CITY OF NAPOLEON - BUILDING DEPARTMENT

RESIDENTIAL PLAN CORRECTION SHEET

ADDENDUM TO PERMIT NO. 01882 - (1)
 Owner MARILYN SPANE
 Contractor L.V. TRUMB
 Location 122 SHEFFIELD

FIELD CORRECTION NOTICE

SUBJECT M. STONE 120 SHELFIELD NAP. OH.

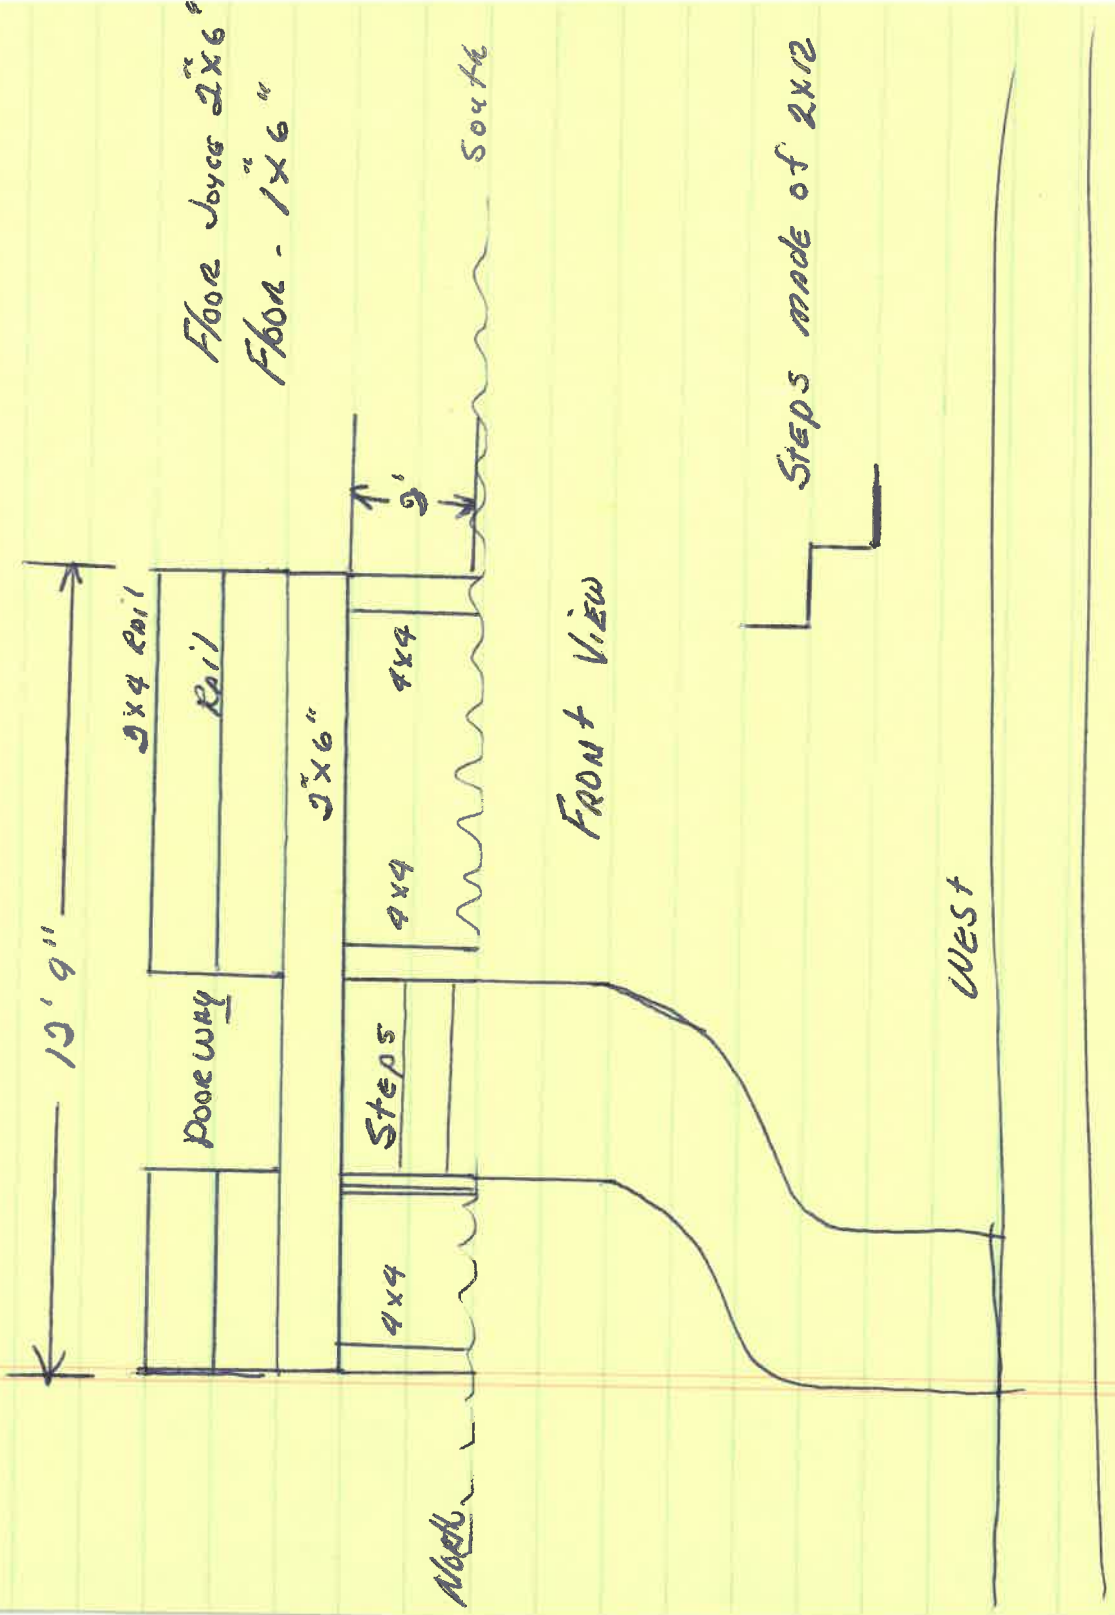
subject PLEASE SUBMIT A

SECTION THRU THE WOOD

DECK AND A STAIR

SECTION SHOWING ALL

STRUCTURAL MEMBERS.

MAX STAIR RISER) = 8 1/4" (YOUR RISER)
MEASURE 9, 10, + 11"
ALL RISERS MUST BE OF EQUAL HEIGHT
+ SHALL NOT EXCEED 8 1/4"
MIN NOSING APPROX 1"

All Lumber is treated
